**Proposal for the 01 series of amendments to UN Regulation No. 35
(ECE/TRANS/WP.29/GRSG/2019/3 on Foot controls)**

The text reproduced below was prepared by the expert from the International Organization of Motor Vehicle Manufacturers (OICA) to clarify the measurement method of the lateral distance of the pedals to the nearest "wall" to the left. It is based on informal document GRSG-115-17, presented at the 115th session of the Working Party on General Safety Provisions (GRSG) (see report ECE/TRANS/WP.29/GRSG/94, para. 14). The modifications to the current text of UN Regulation No. 35 are marked in bold characters.

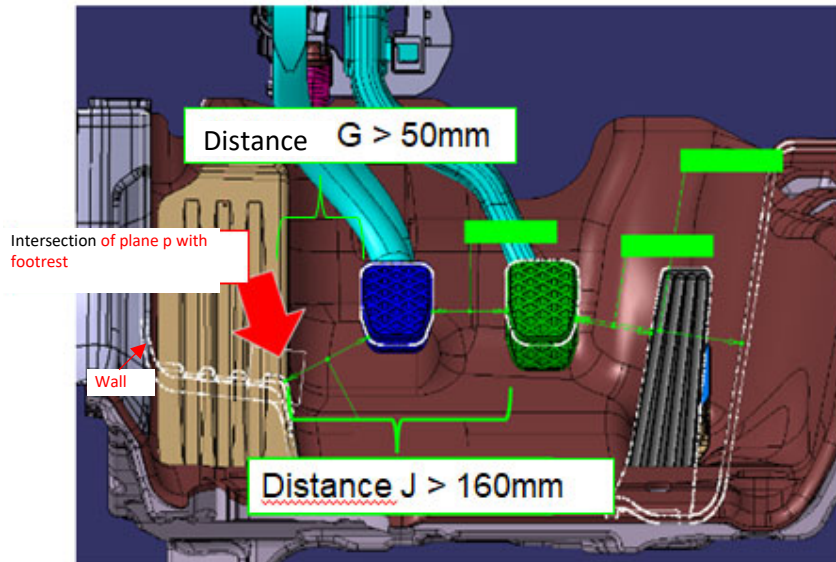
In case of a foot rest as declared by the manufacturer, installed for the driver's left foot, the shortest distance between the most left pedal and the wall shall be measured above the foot rest, and the minimum distance between the footrest and the projection of the most left pedal on to the reference plane "P" shall be ≥ 50 mm."

Current Regulation: Three pedals – Conventional transmission

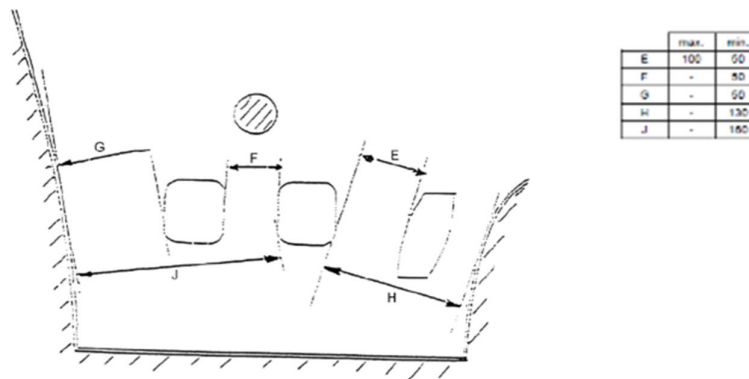
2. This proposal hence clarifies the measurement method for the lateral distances of the pedals to the nearest "wall" to the left. For safety and comfort reasons foot rests are installed for the drivers' left foot. The rest plane of such foot rests can intersect the measurement plane "P". This proposal clarifies that, in such cases, the required clearance for the left foot is measured on top of the foot rest, rather than between the left most pedal and the foot rest itself.

Example of possible interpretation when footrest exists under current regulation text:

Current Regulation Text: Two pedals – Automatic transmission

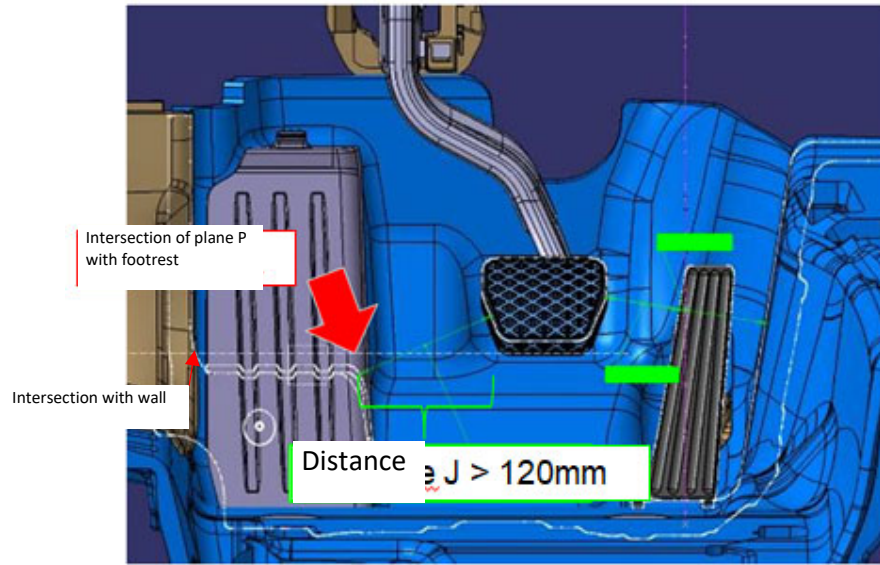
Example of possible interpretation when footrest exists under current regulation text:
